U. S. ARMY ENGINEER DISTRICT, JACKSONVILLE  
 CORPS OF ENGINEERS  
 JACKSONVILLE, FLORIDA  
 CENTRAL AND SOUTHERN FLORIDA PROJECT  
 FOR FLOOD CONTROL AND OTHER PURPOSES  
 CANAL 54 SECTION 2  
 GATED CULVERT STRUCTURE CS-3  
 GENERAL PLAN AND SECTIONS

DESIGNED BY A.S.P.	CHECKED BY A.S.P.	DATE: 28 APRIL 1966	SCALE: AS SHOWN
REV. NO. CIV. ENG. 06-123-66-26	SIZE: 11x17	DATE: APRIL 1966	DATE: APRIL 1966
SHEET 65 OF 72		92 105

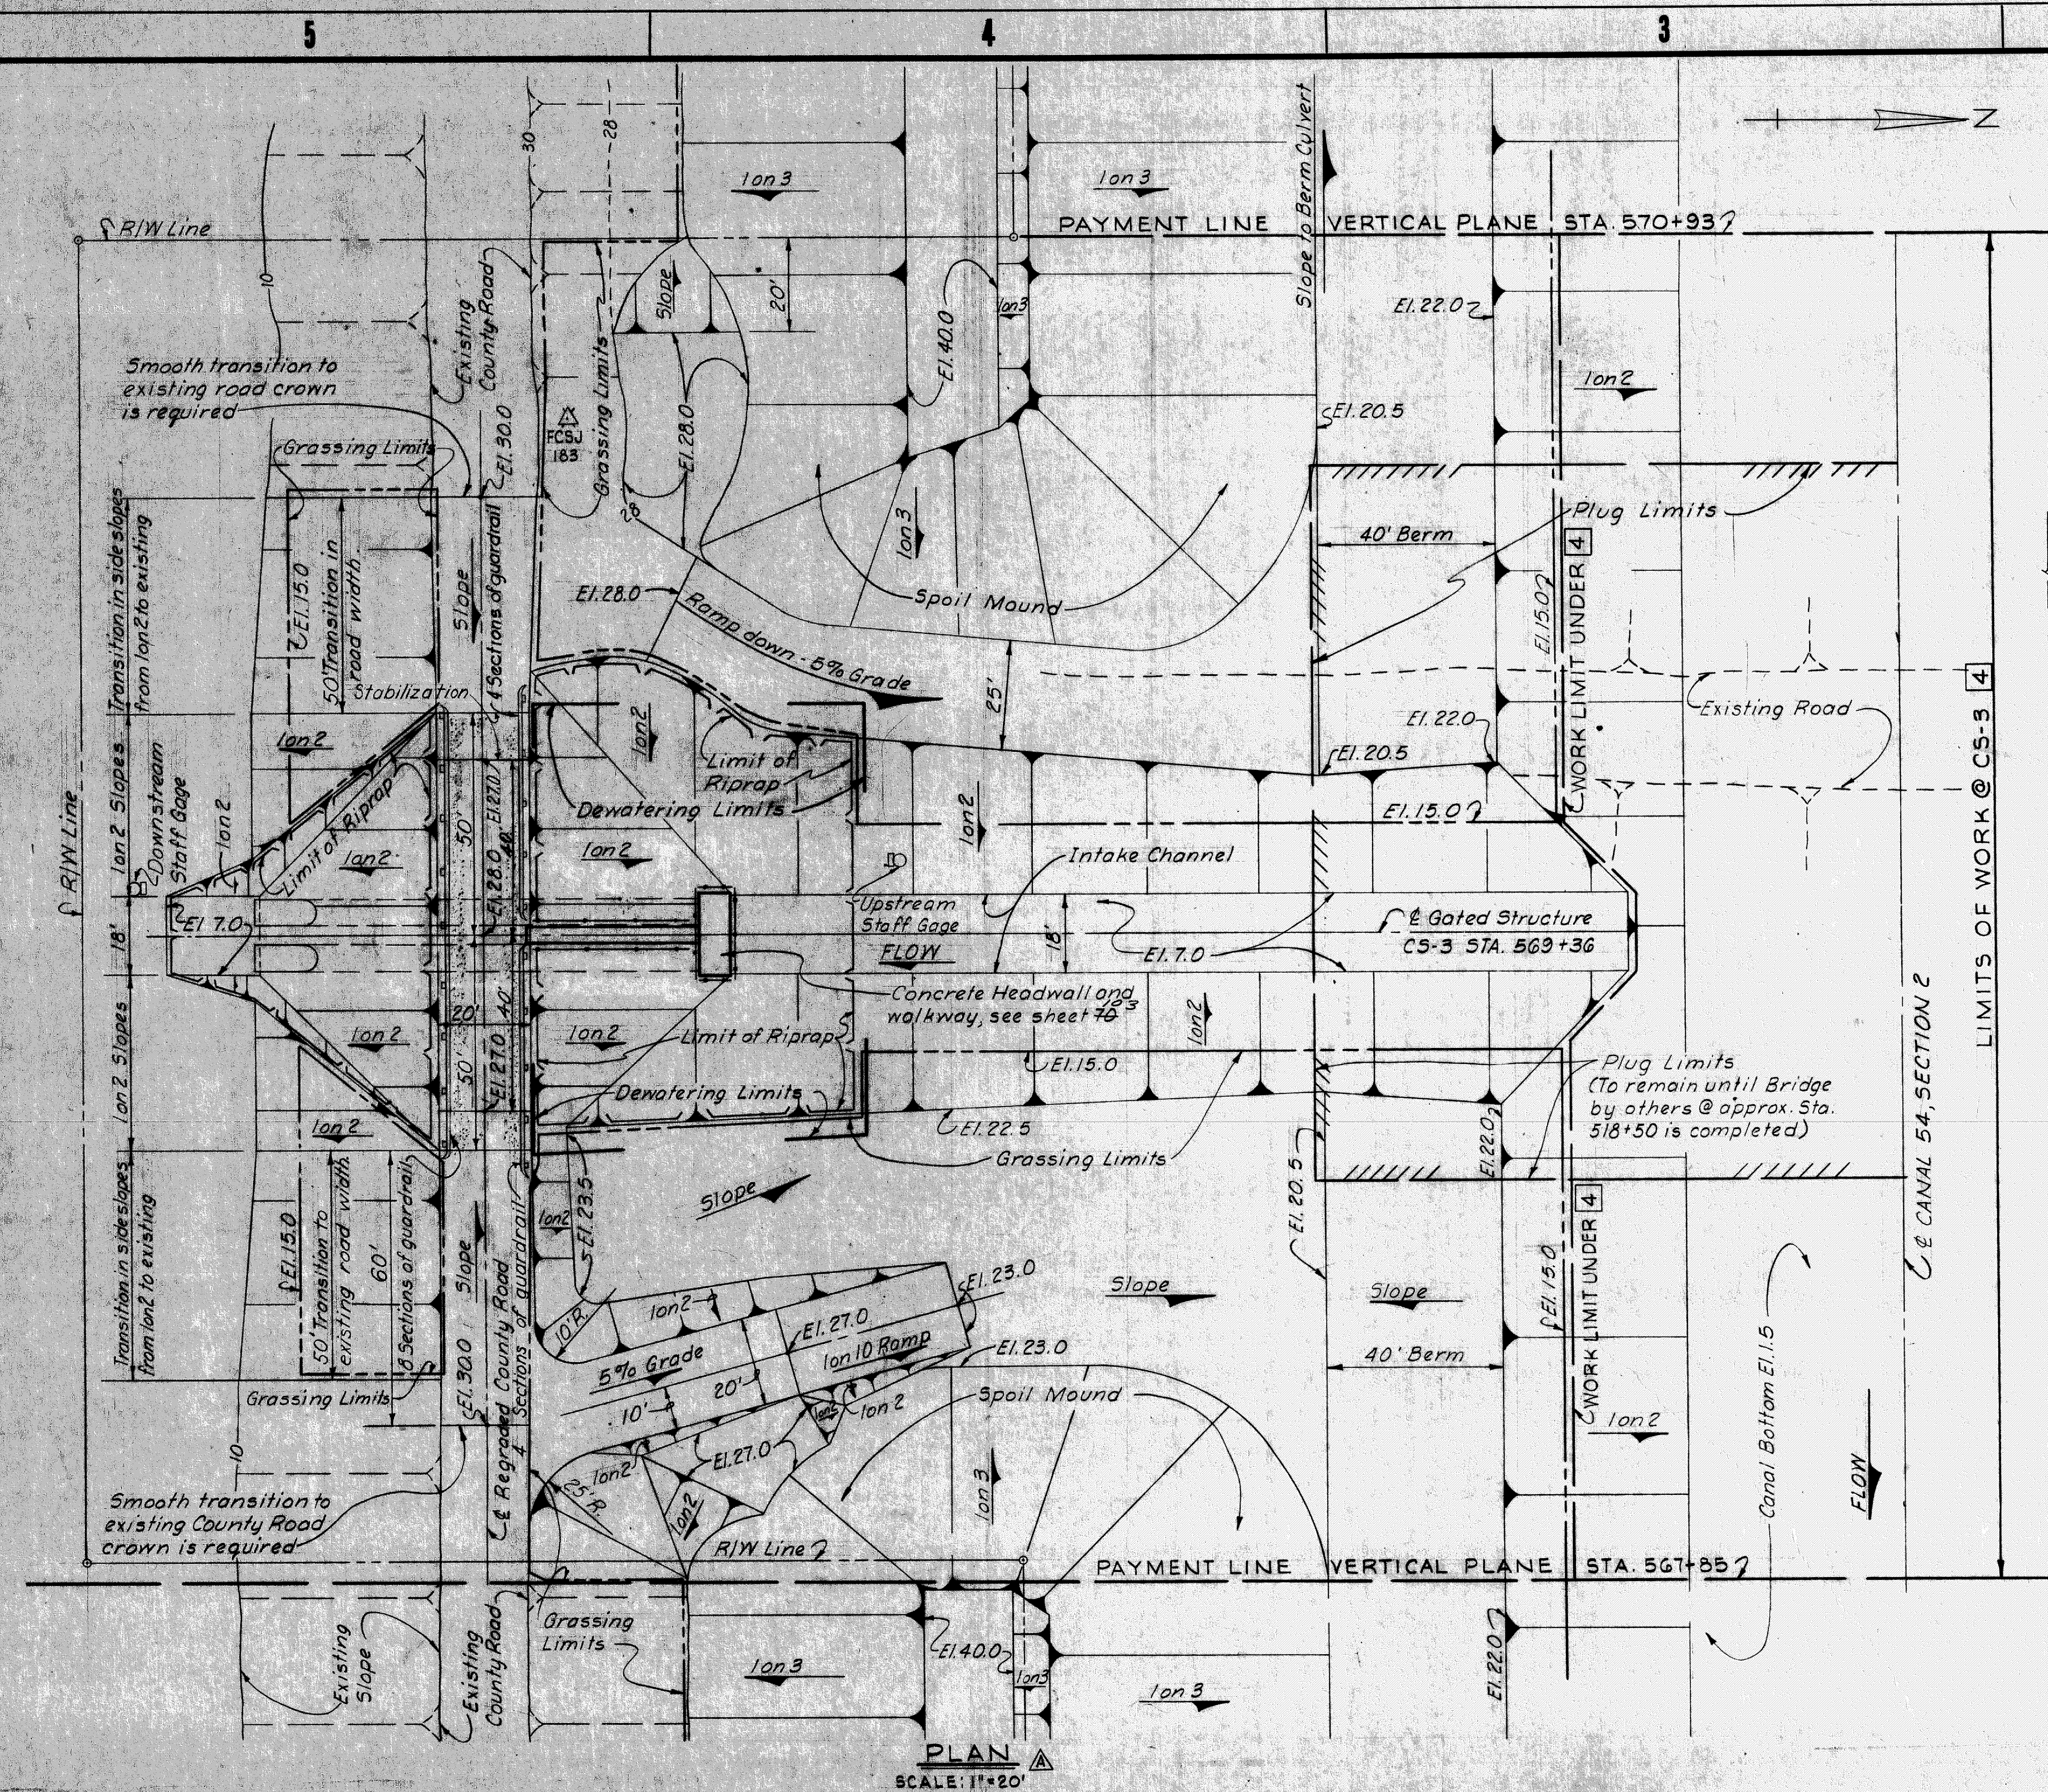
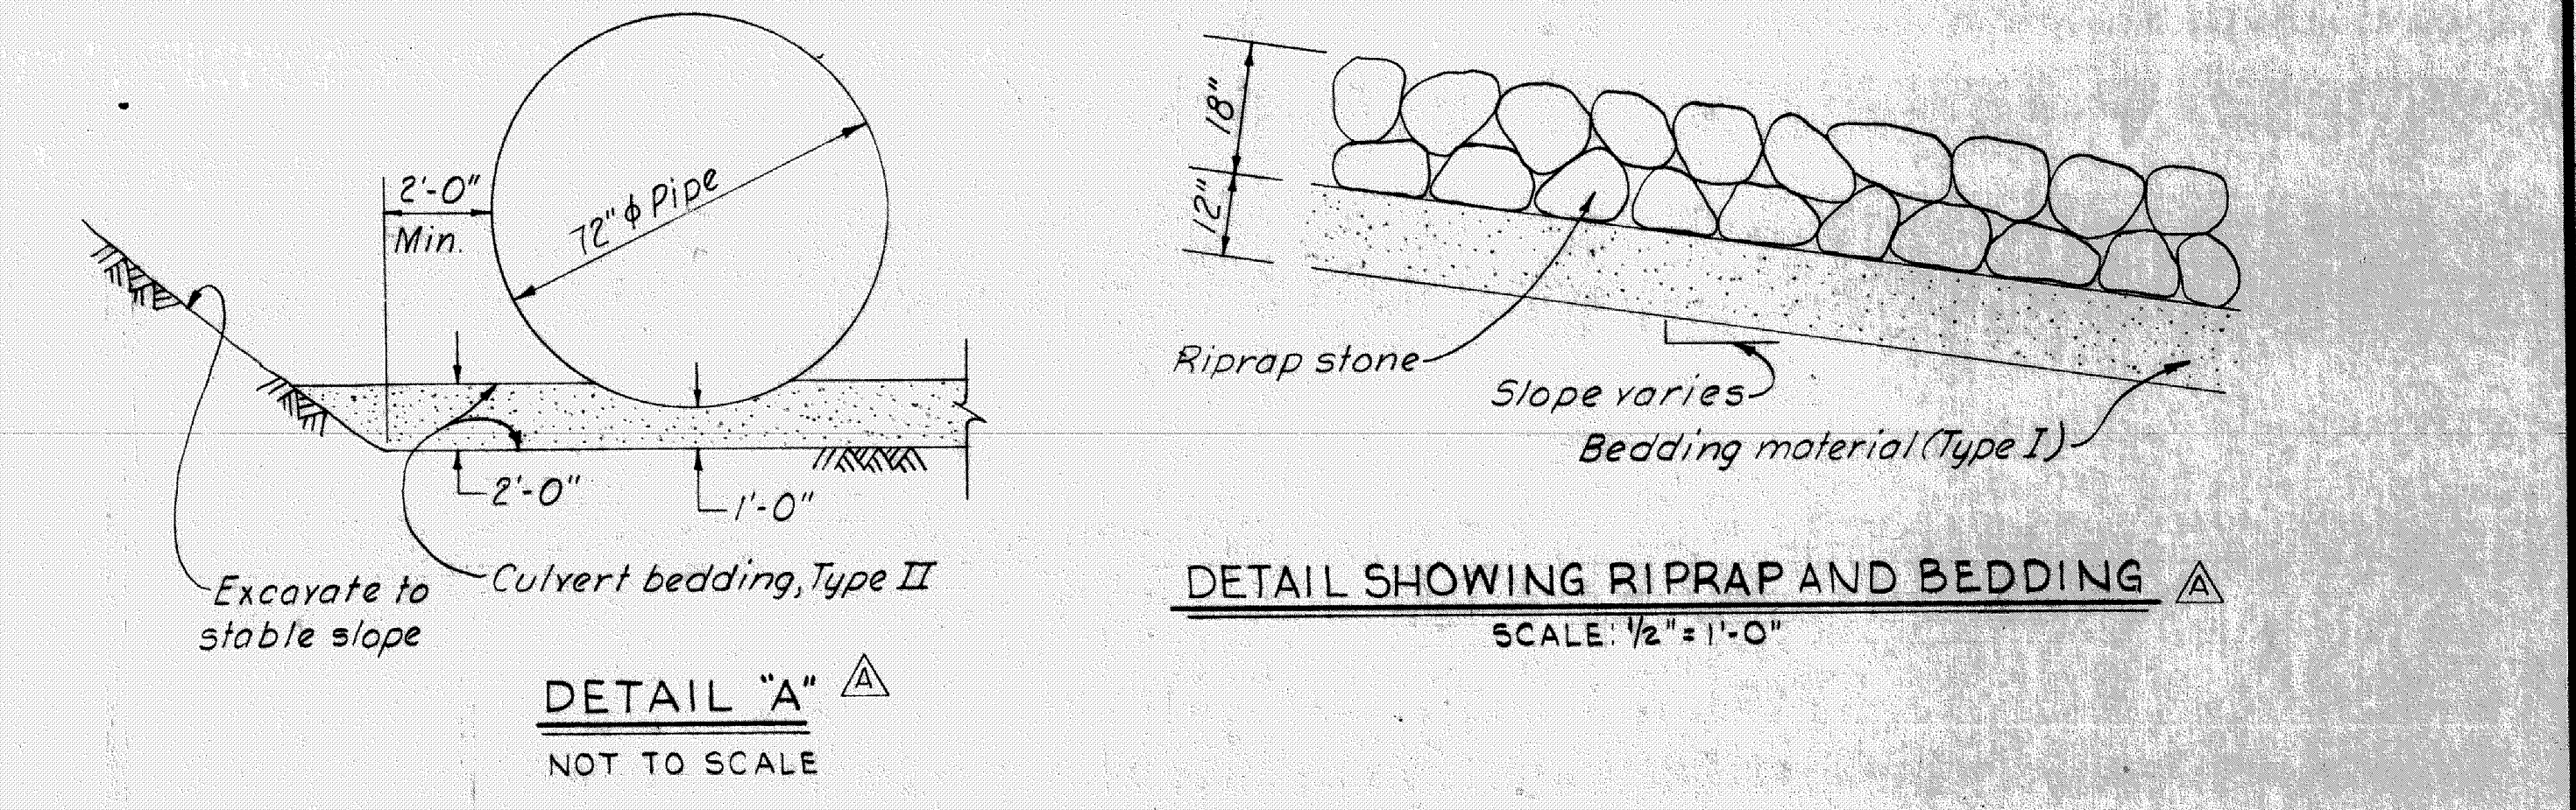
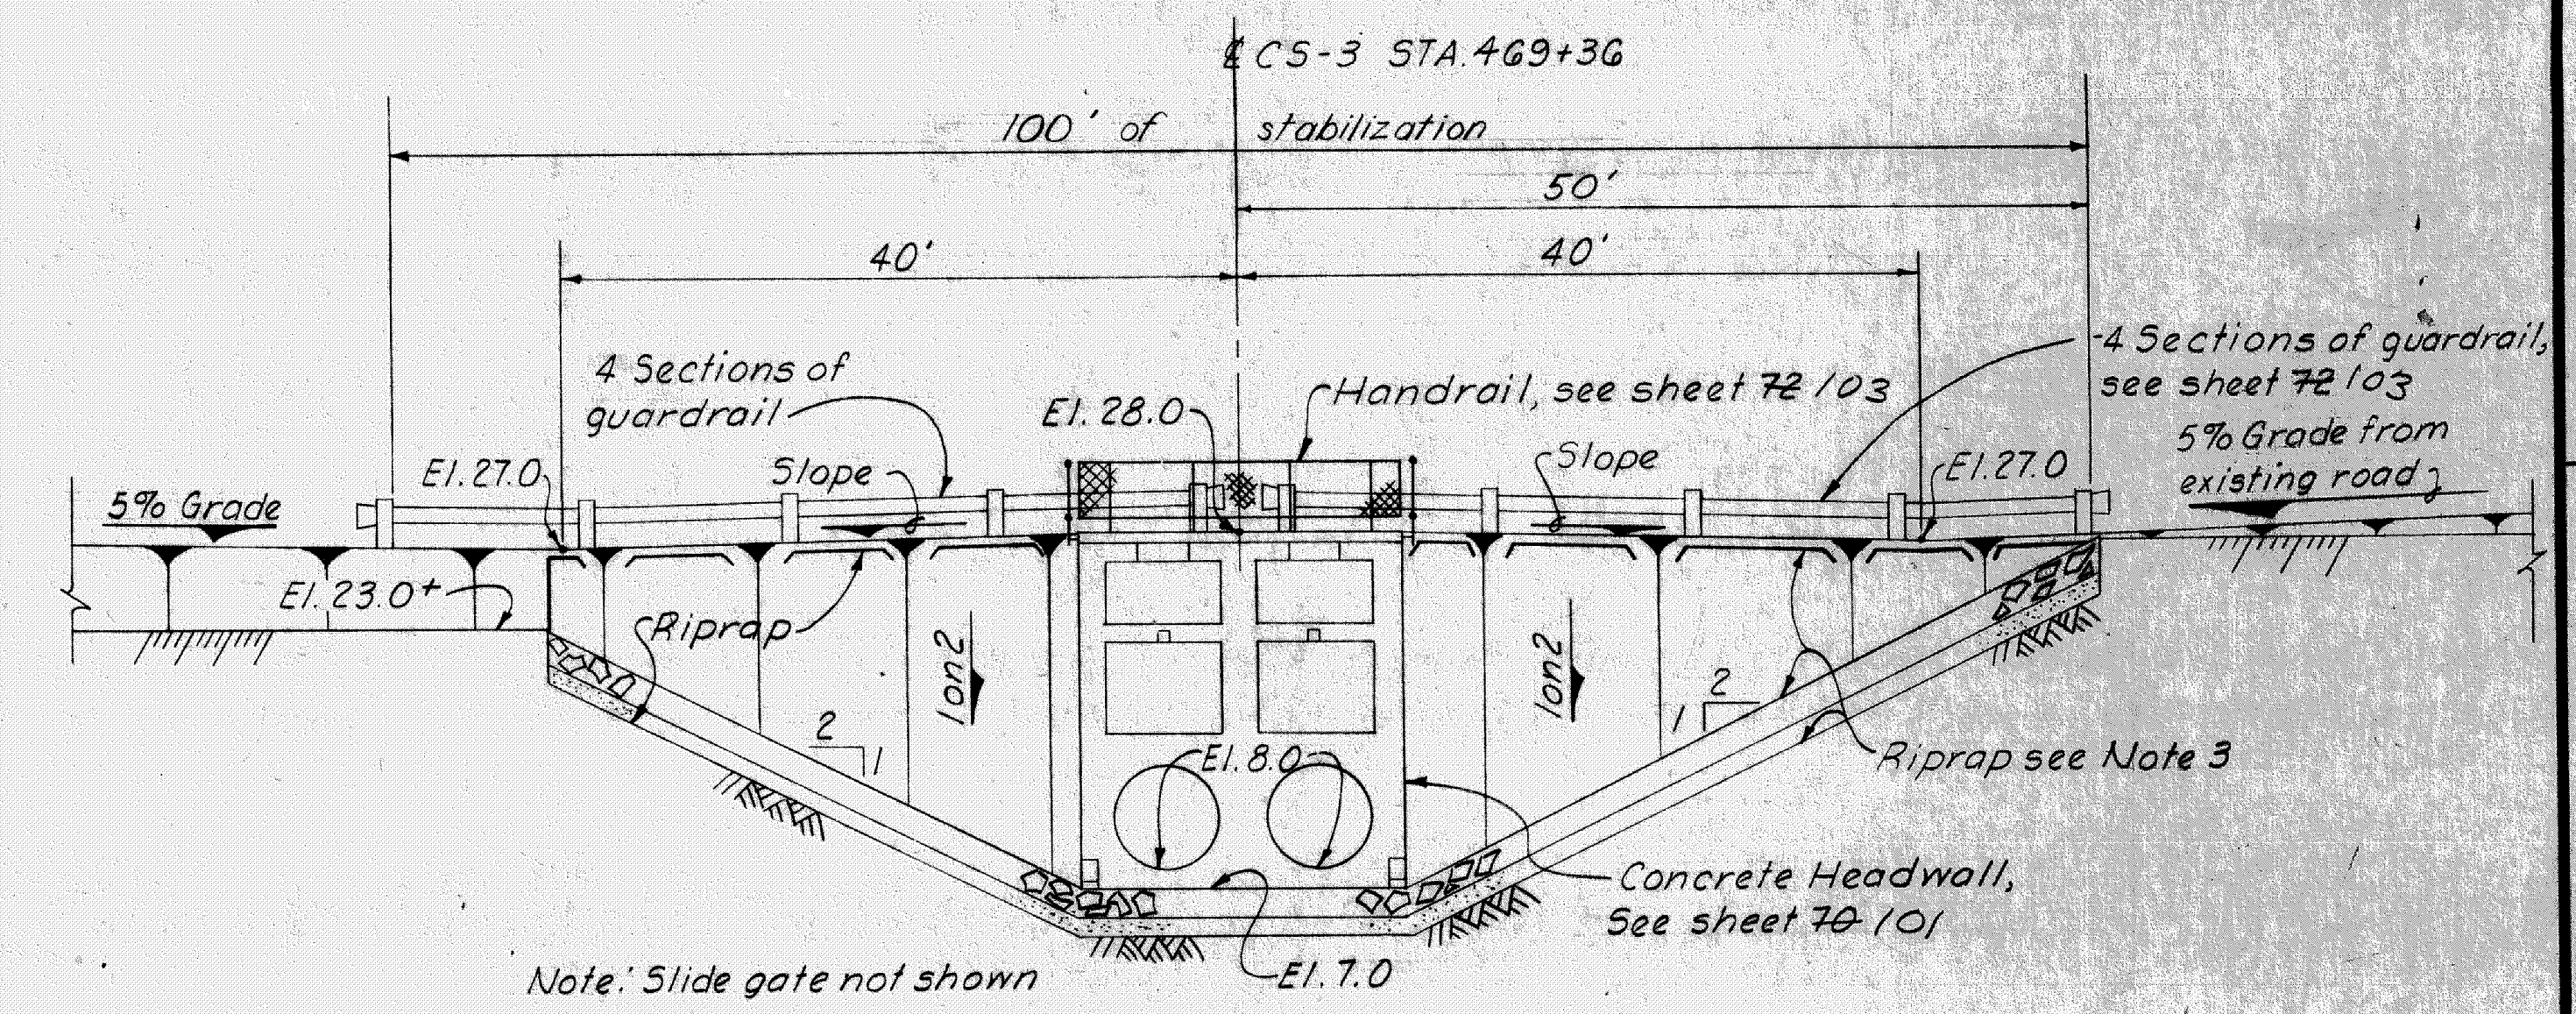
REVISIONS					
NO.	SYM.	ZONE	DESCRIPTION	DATE	APPROVED
5	▲		REVISED PLAN AND SECTION AT CS-3 AND ADDED UPSTREAM ELEVATION. DETAIL A. DETAIL SHOWING RIPRAP AND BEDDING. ADD NOTES 1-THRU 7 TO ACCOMPANY AMENDMENT NO. 2.	5-14-66	aw
